SUBJECT: NuScale Power, LLC Response to NRC Request for Additional Information No. 167 (eRAI No. 8964) on the NuScale Design Certification Application

Enclosure 1: NuScale Response to NRC Request for Additional Information eRAI No. 8964

NRC Question No.: 03.08.05-2

Figure 1 - Edge and Center Nodes at Bottom of Foundations Selected for Building Settlement Assessment

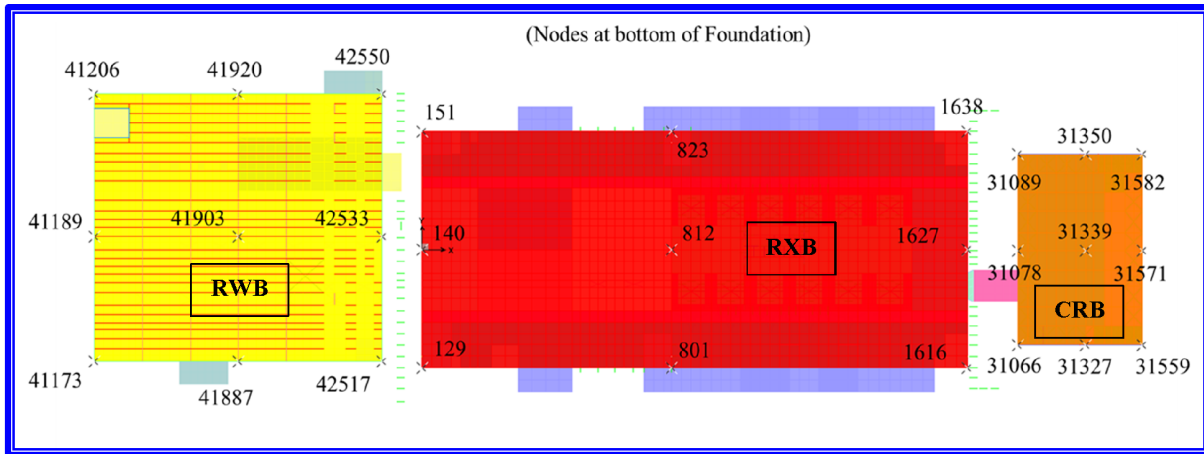
In FSAR Tier 2, Section 3.8.5.6.7, “Basemat Soil Pressures along Basemat Edges (Toe Pressures),” the applicant performed analyses to determine the edge bearing pressures (or toe pressures) along the edges of the seismic Category I structure basemats (RXB and CRB). In FSAR Tier 2, Section 3.8.5.5.5 “Settlement Approach,” the applicant considered a condition of the soil stiffnesses that are further reduced by 50 percent to amplify the effect of settlements. Therefore, provide information on associated settlements due to soft soil stiffnesses along the edges of the seismic Category I structure.

The foundation displacement results from the static, flexible-base triple building model are presented. The displacements, due to soft soil stiffness, are presented for selected nodes along the foundation edge of the RXB, CRB, and RWB in Table 1 and Table 2 for uncracked and cracked conditions, respectively. The location of the nodes are shown in Figure 1.

The displacement results and associated figure have been added to FSAR Tier 2, Section 3.8.5.
